**PLANNING COMMISSION STAFF REPORT**  
MAJOR MODIFICATION OF CRESTVIEW CROSSING PUD/CUP  
FILE NO. MAMD323-0001 - HWY 99W AND E CRESTVIEW DRIVE

**FILE NO:** MAMD323-0001

**REQUEST** Request for a major modification of a previously approved Planned Unit Development (PUD18-0001) and Conditional Use Permit (CUP18-0004) to construct 196 multi-family dwelling units in eight multi-family structures.

SHEET NUMBER  
**C202**

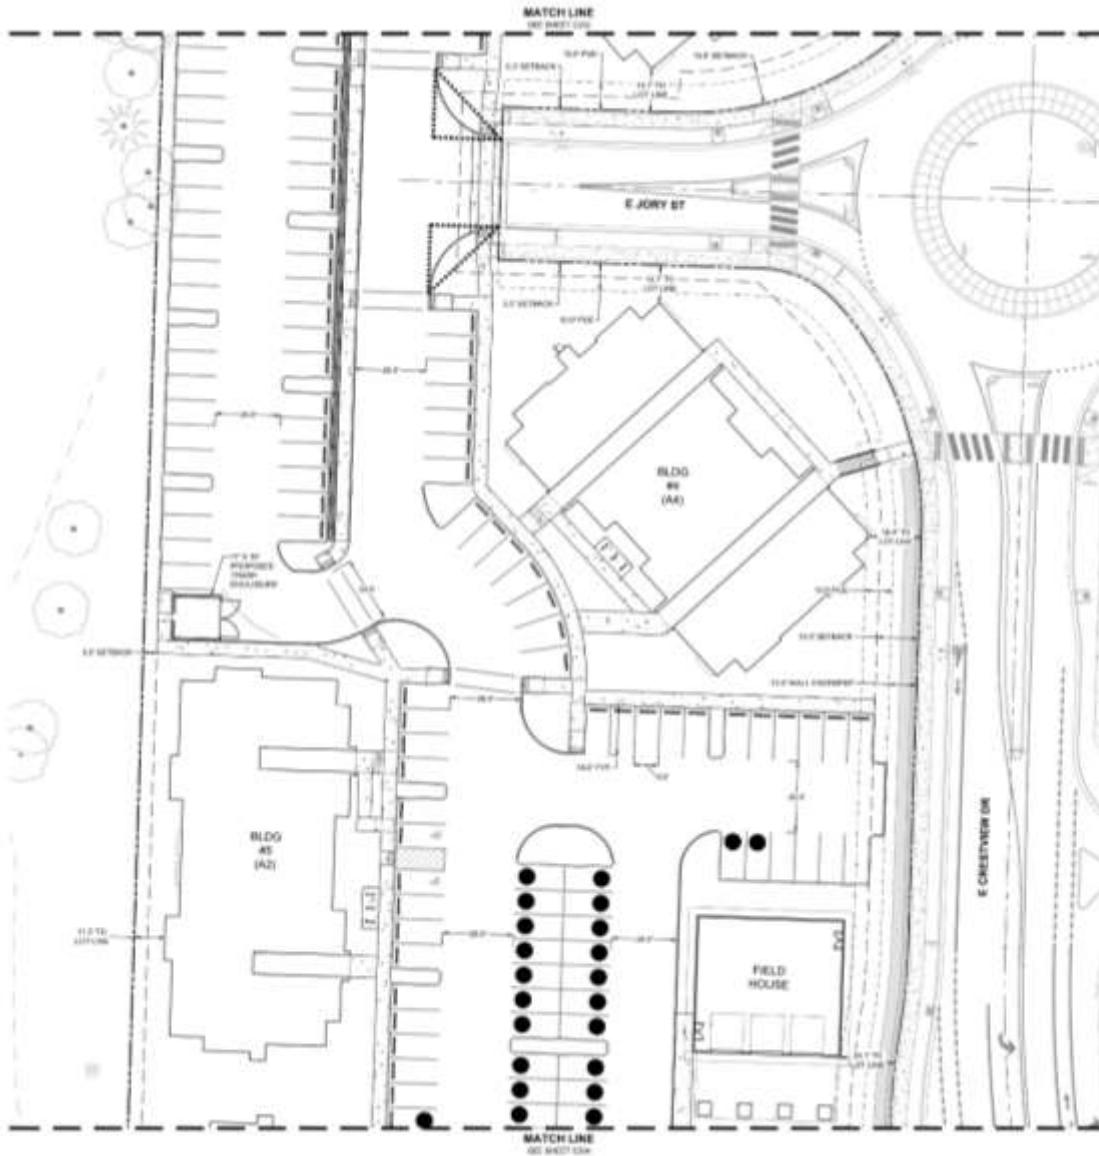
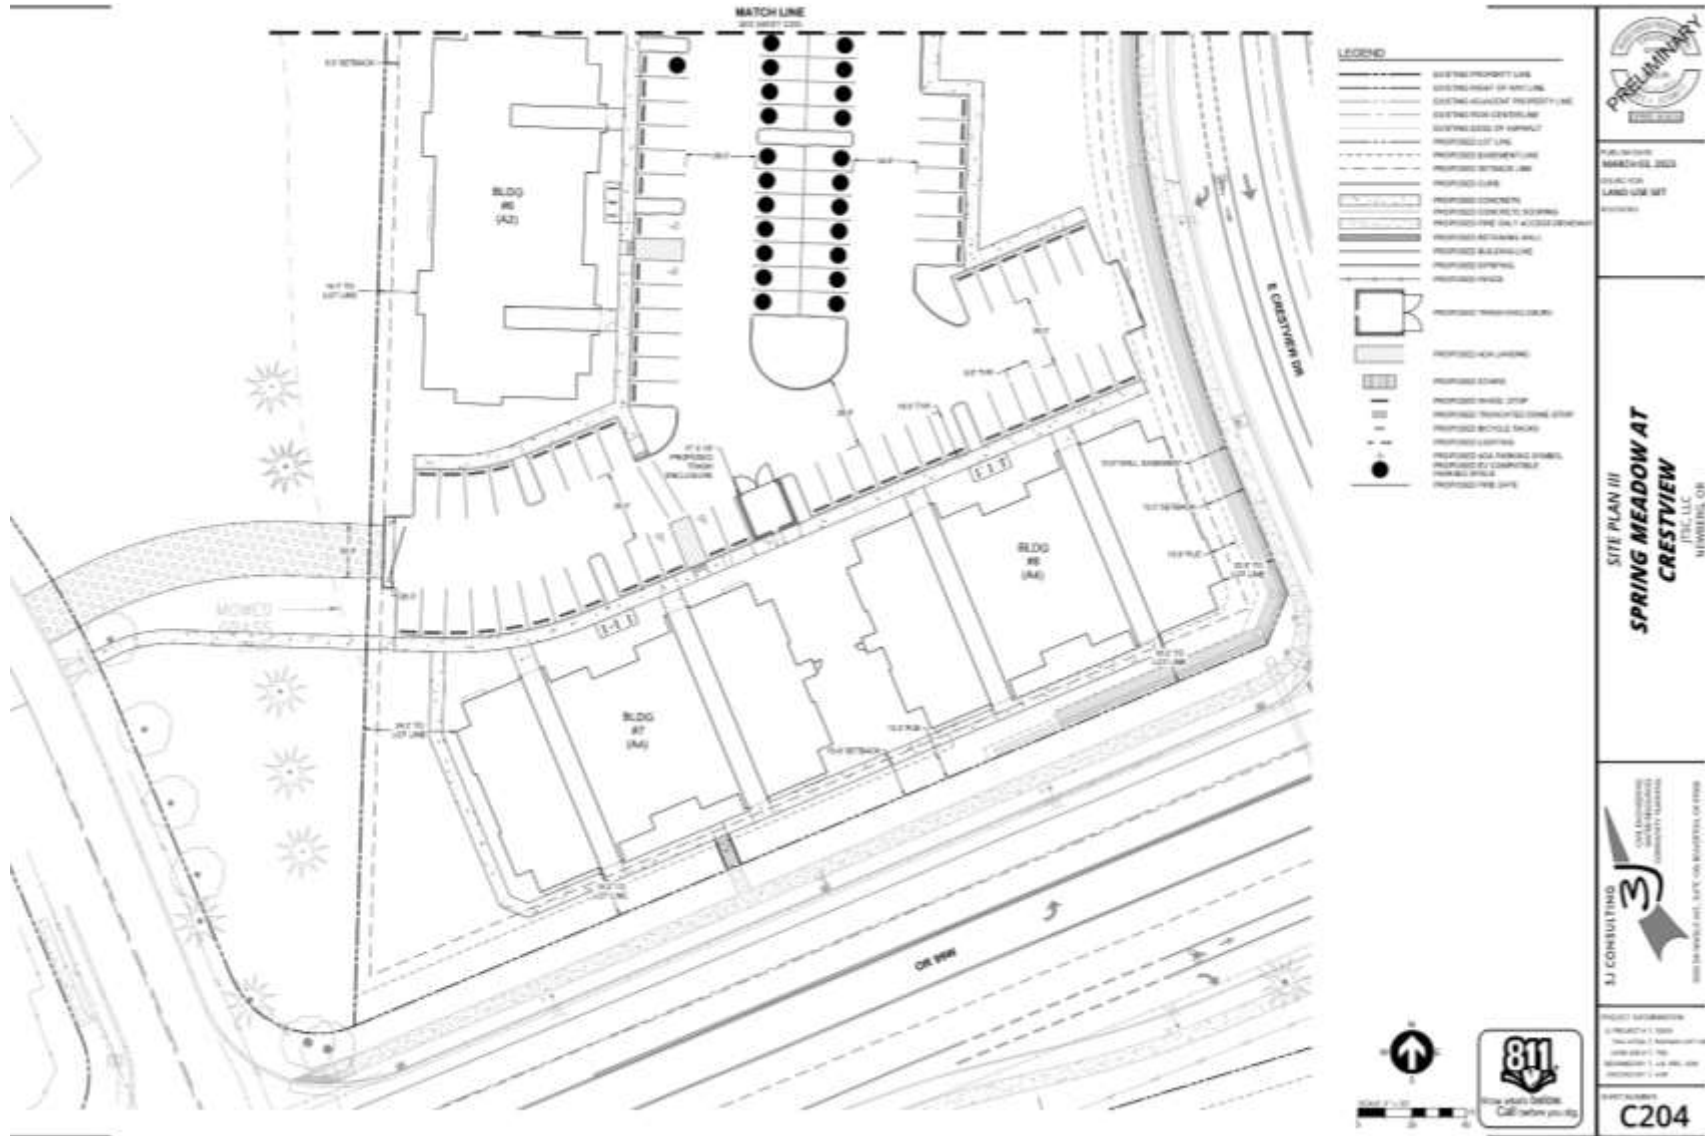
1. Building #7 more than 7 spaces in a row.
2. Check lighting plan for compliance.
3. Check density point calculations.
4. PUD Homeowners Association.

Because the line of parking stalls located immediately north of Building #7 possesses 8 parking stalls in a continuous row it exceeds the standard identified in NMC 420.010(B)(3)(h) which states that no more than seven parking spaces may be grouped together without an island separation unless otherwise approved by the director. The Applicant shall modify the proposed parking configuration to comply with NMC 15.420.010(B)(3)(h); provide a continuous landscaped strip, with a five-foot minimum width, which runs perpendicular to the row of parking spaces (see NMC, Title 15, Appendix A, Figure 13); or provide tree planting landscape islands, each of which is at least 16 square feet in size, and spaced no more than 50 feet apart on average, within areas proposed for back-to-back parking (see NMC Title 15, Appendix A, Figure 14).

1. The Applicant shall modify the proposed parking configuration to comply with NMC 15.420.010(B)(3)(h); provide a continuous landscaped strip, with a five-foot minimum width, which runs perpendicular to the row of parking spaces (see NMC Title 15, Appendix A, Figure 13); or provide tree planting landscape islands, each of which is at least 16 square feet in size, and spaced no more than 50 feet apart on average, within areas proposed for back-to-back parking (see NMC Title 15, Appendix A, Figure 14).
